REMARKS

Corrected Formal Drawing

Appl. No.: 09/670,840
Docket No.: 1248-0518P
, Reply to Office Action of November 13, 2003

FIG. 7 (b)

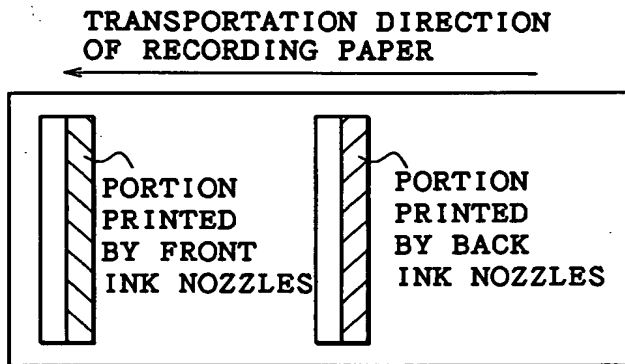
In amended Figure 7(b), the top arrow previously pointing right is amended to an arrow pointing left. The minor change to Fig. 7(b) is made so that the figure is consistent with the statements in the specification.
